WATTS BAR NUCLEAR PLANT (WBN) UNITS 1 AND 2 - REQUEST FOR ADDITIONAL
INFORMATION ON FSAR CHAPTER 3 AS REVISED BY AMENDMENT 79 (TAC NOS. M88488
AND M88489)

This letter provides TVA's response to the NRC's request for additional
information (RAI) dated October 11, 1994, concerning the subject FSAR
chapter for WBN.

WATTS BAR NUCLEAR PLANT UNITS 1 AND 2 FINAL SAFETY ANALYSIS REPORT (FSAR), CHAPTER 3 REQUEST FOR ADDITIONAL INFORMATION (RAI) RESPONSE

Figure 5.5--6 Reactor Vessel Supports

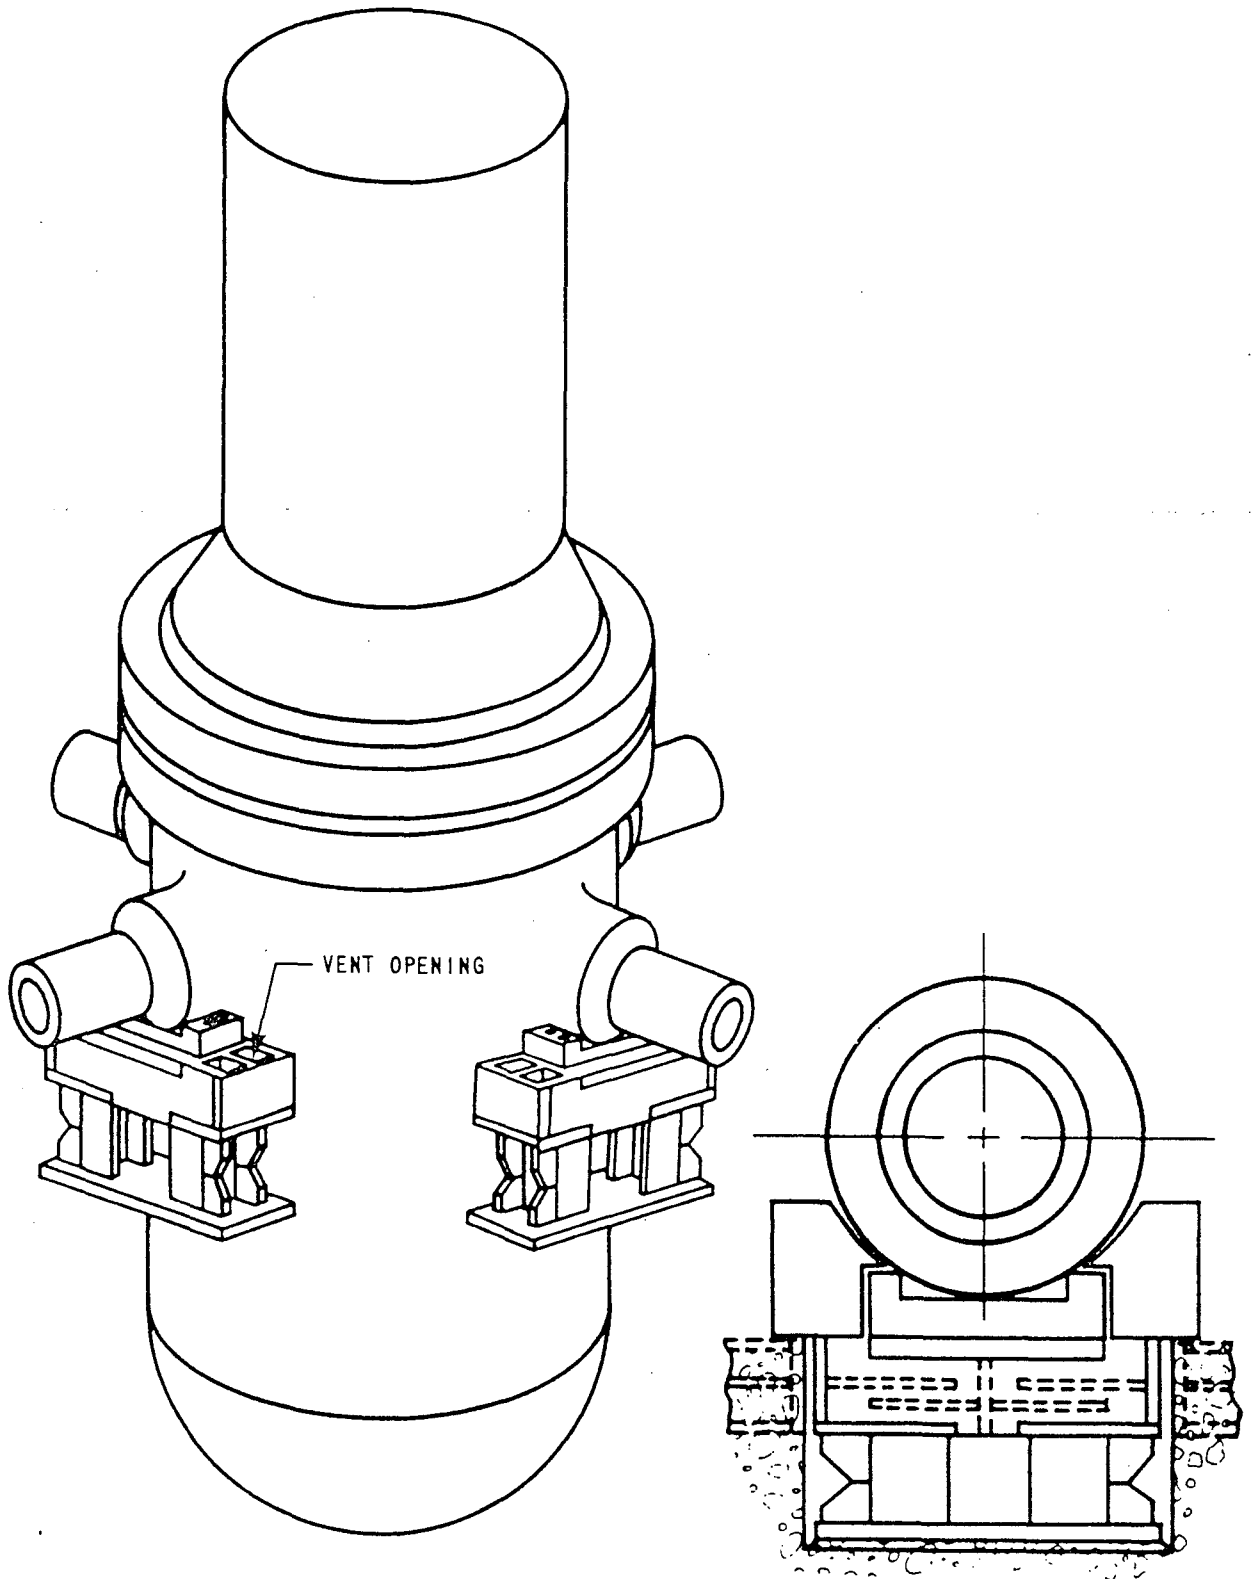
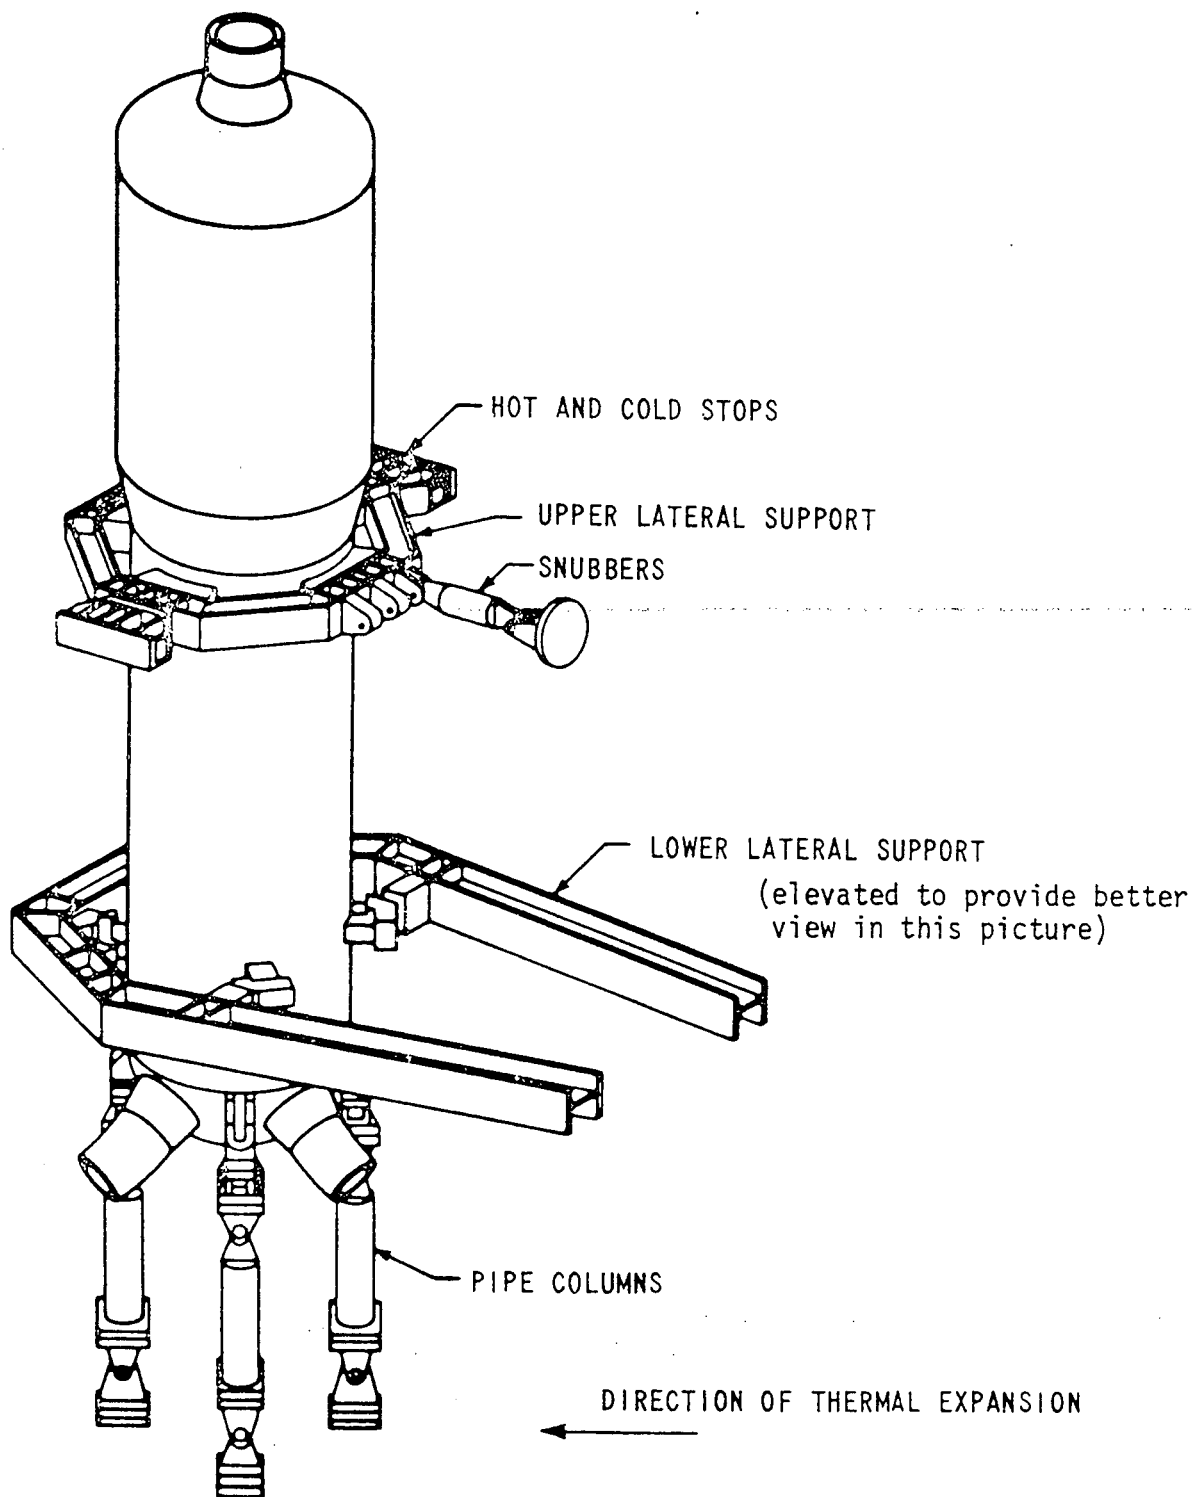
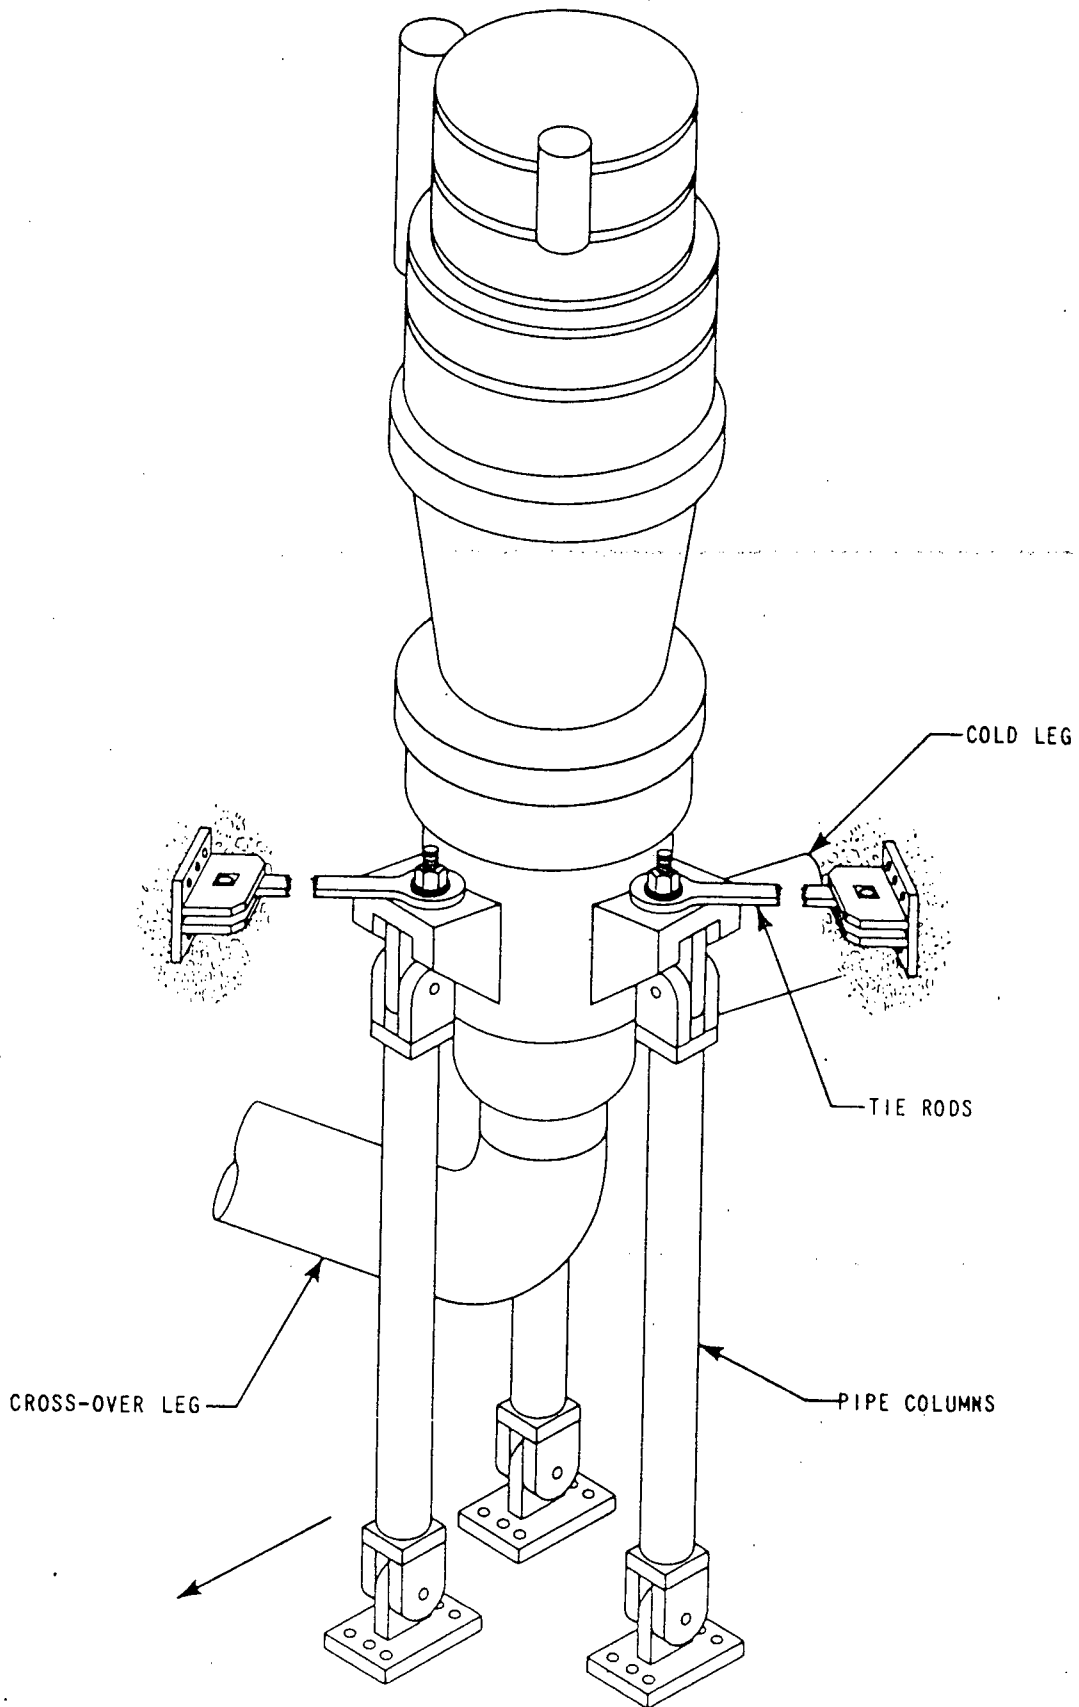
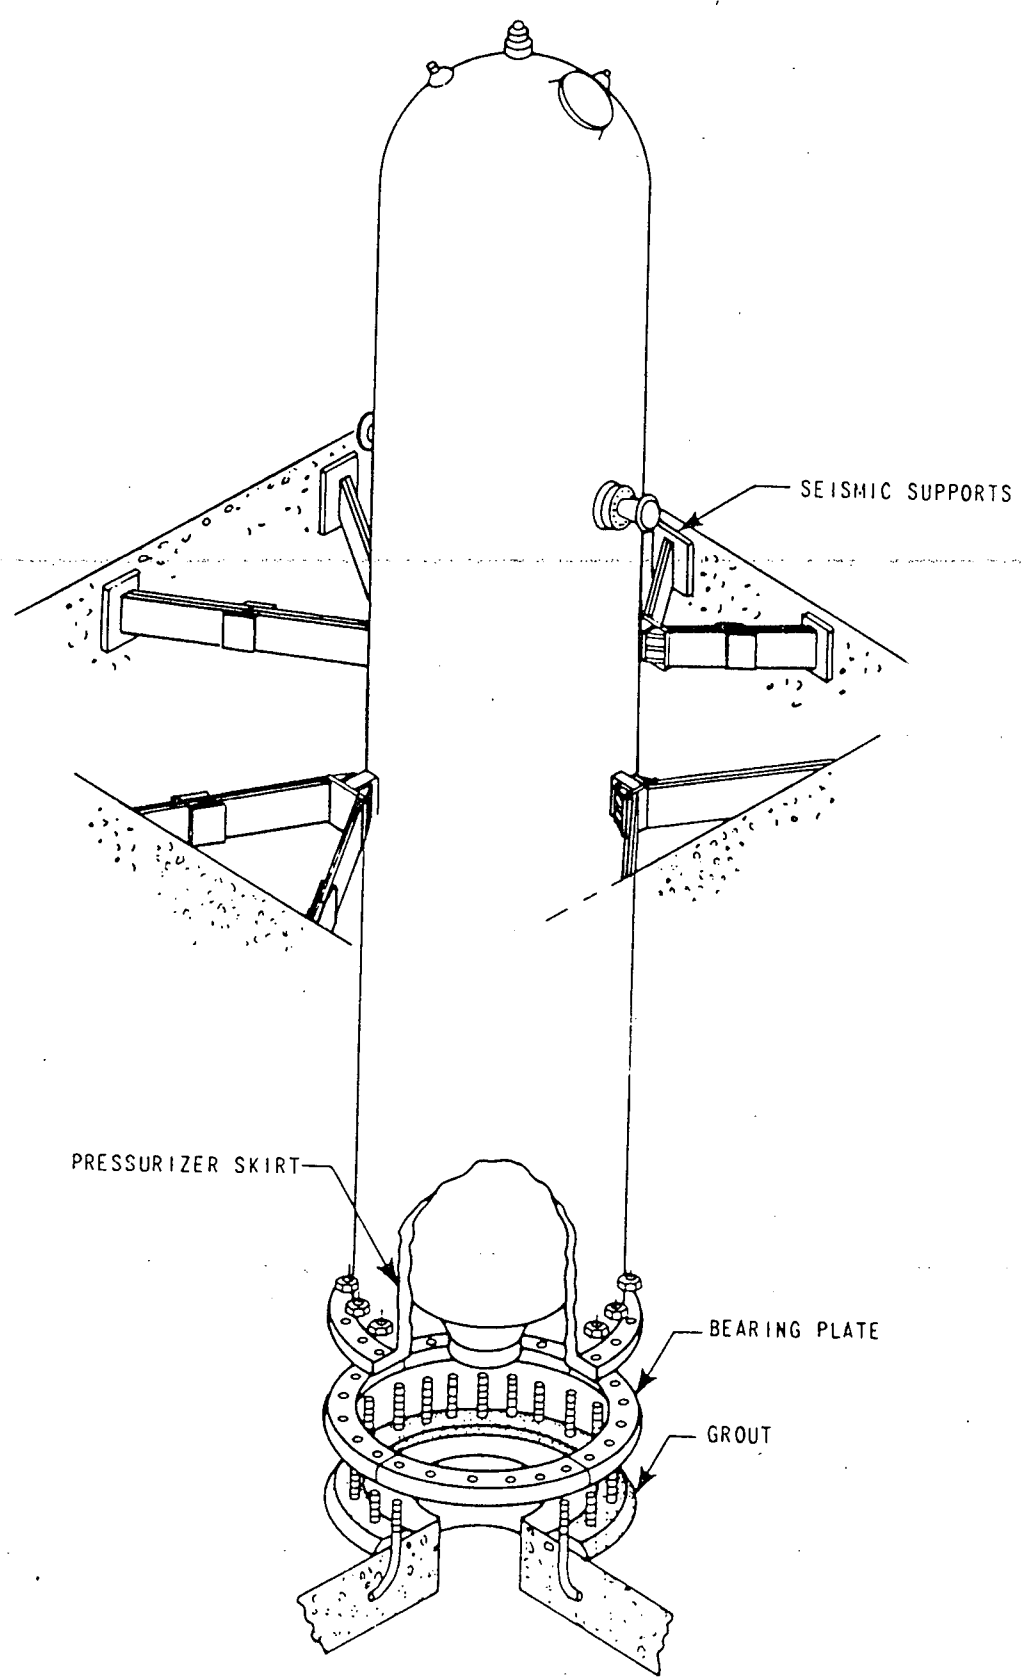
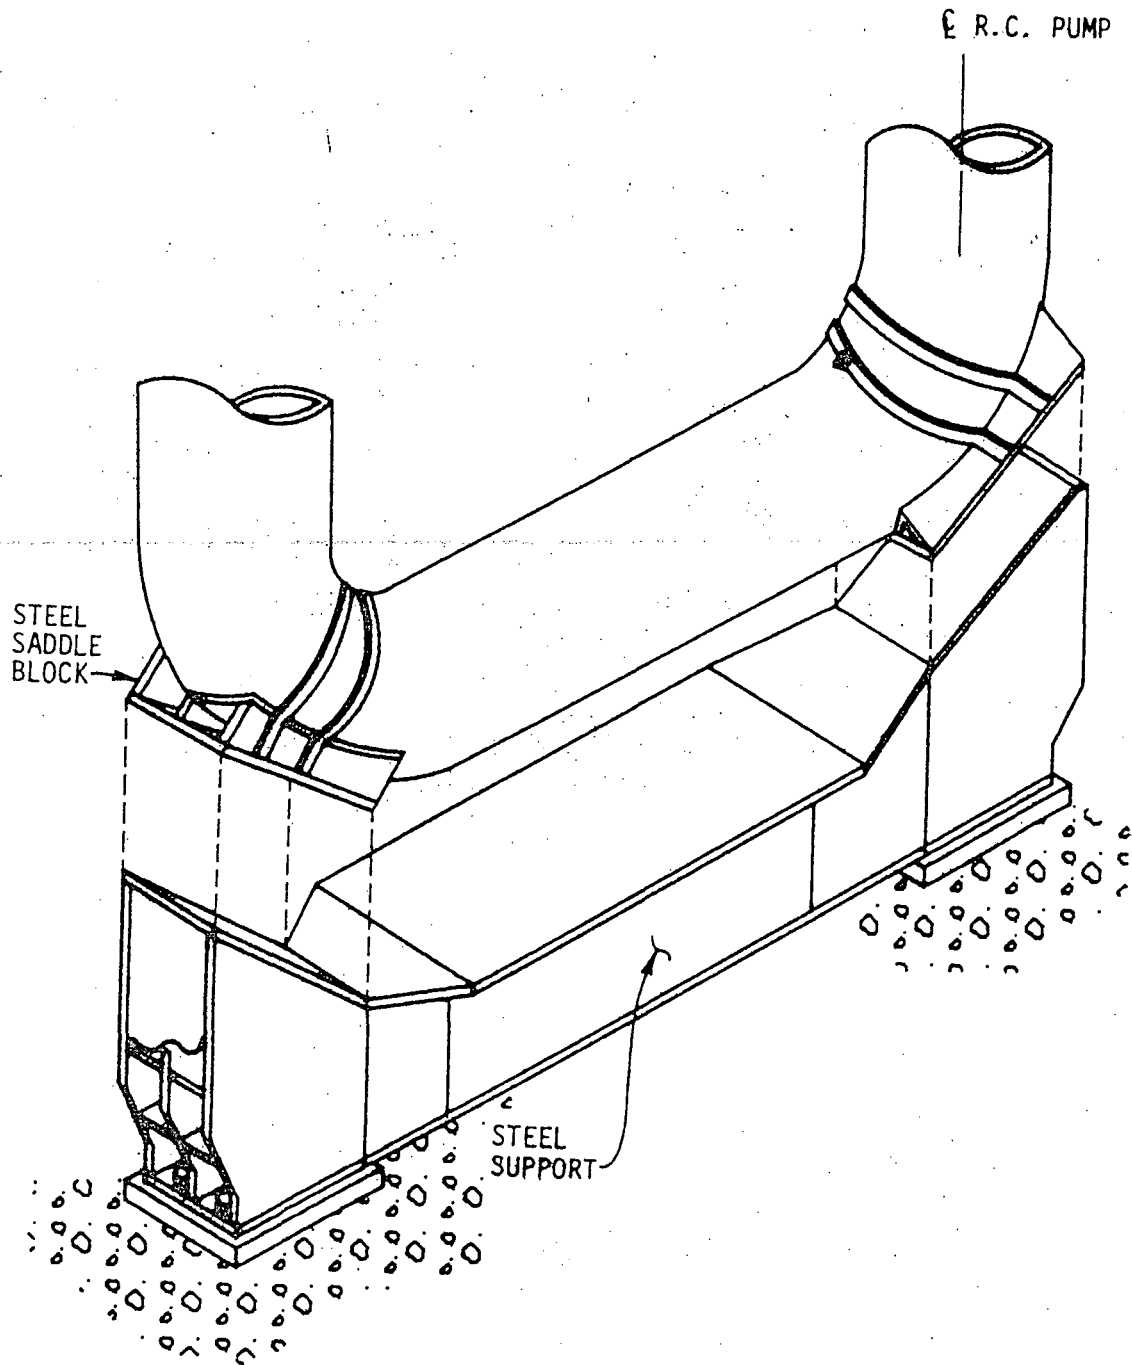
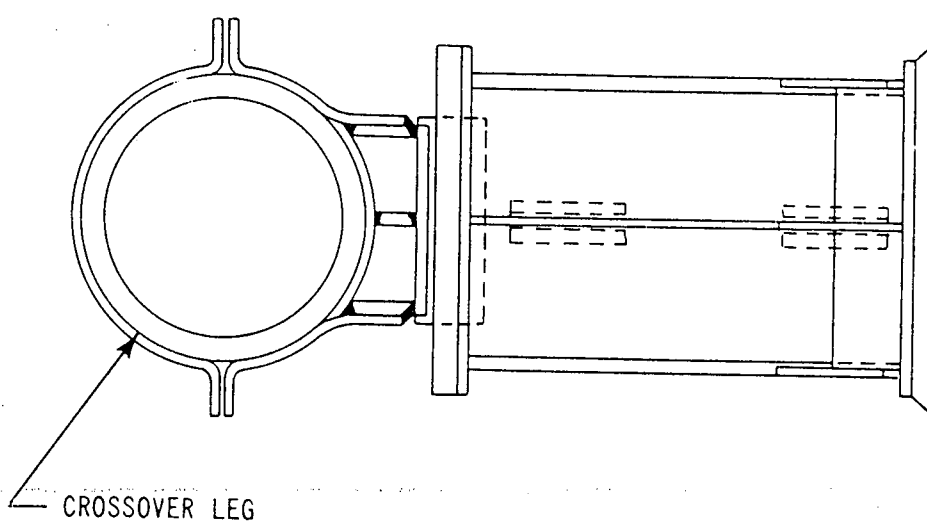
1. Geometry and sketches of the model,
2. Engineering data, such as, mass, spring, damping, size and location of the gaps, location of one-way hangers,
3. Description of modelling of gap and one-way hanger and validation of such model,
4. Detailed description of four linearized NSSS support stiffness and a discussion of how such supports adequately represent the nonlinear system being evaluated,
5. Discussion of governing equation of motion and the validation of numerical integration algorithm including stability and error estimate as discussed in "Analysis of Numerical Methods," E. Isaacson and H. B. Keller, 1966 .
6. Validation of overall model and
7. Summary of the calculated stresses of the critical members both in concrete structure and piping and supports, corresponding allowable stresses and references from which the allowable stresses are quoted."

Gaps are provided in NSSS component support arrangements to enable the virtually unrestrained thermal movement of the loops and the components during plant operation. However, the support structures are of welded steel construction and fabricated in such a way that while the supports permit unrestrained thermal growth of the supported systems, the supports would provide restraints to the vertical, lateral and rotational movement resulting from seismic and/or accident conditions. This is accomplished by using (1) pin ended columns for vertical support and (2) girders, bumper pedestals, hydraulic snubbers, and tie rods for lateral support. The detailed description for the NSSS component supports is provided in FSAR Figures 5.5-6 through 5.5-13 (See Attachment 1).
